SATARA WIND POWER PROJECT IN MAHARASHTRA, INDIA

Project Title	Satara Wind Power Project in Maharashtra, India
Version	1.1
Report ID	VKU.VER.03.22_VCS_1519

Report Title	Satara Wind Power Project in Maharashtra, India
Client	WeAct Pty Ltd
Pages	86
Date of Issue	08-September-2023
Prepared By	VKU Certification Pvt. Ltd.
Contact	Regd. Off: Flat No. 306, Sky Star, N-1, New Rani Bagh Khandwa Road, Indore, Madhya Pradesh - 452020 URL: http://vkucertification.com e-mail: info@vkucertification.com
Approved By	Dr. Vikas Kumar Aharwal (Founder and Director) vikas.aharwal@vkucertification.com
Work Carried Out By	Mr. Abhishek Kumar Srivastava - Team Leader cum Technical Expert TA 1.2 (Local Expert – Country: India) Ms. Niharika Kaushik - Validator/Verifier-Trainee Mr. Sanjay Kumar- Technical Reviewer cum Technical Expert TA 1.2

Figure No 02: Project Single Line Diagram

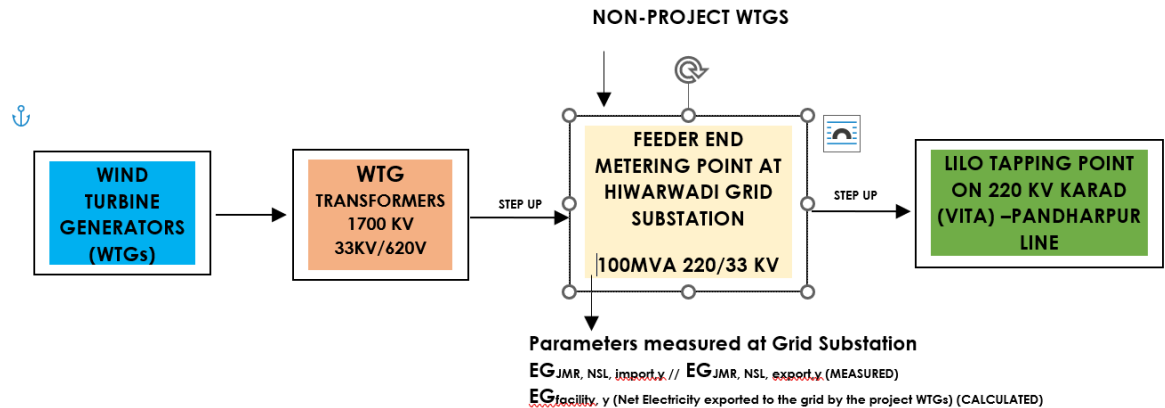
5. In the diagram PP is requested to demarcate the plant boundary and project boundary, show the metering points and the attendant parameter measured by the metering points.

1. PP has submitted the commissioning certificates for the project activity 2. The section 1.6 has been updated 3. A single line diagram has been included that shows the project boundary in line with the registered project boundary 4. The required declaration copy has been submitted to VVB 5. The declaration copy submitted to VVB also clarifies no double accounting of ERs. 6. PP has already submitted the project site attendance sheet and employee training records. This serves the evidence of employment. Also, during the site visit audit VVB was accessible to interact with the local employees as well as the managing staff which are the direct beneficiaries under SDG 8.5.1 Attached: Revised MR version 02, dated 27 Sep 2022		
1 st Assessment by Audit Team	Status	Open
	Date	20-October-2022
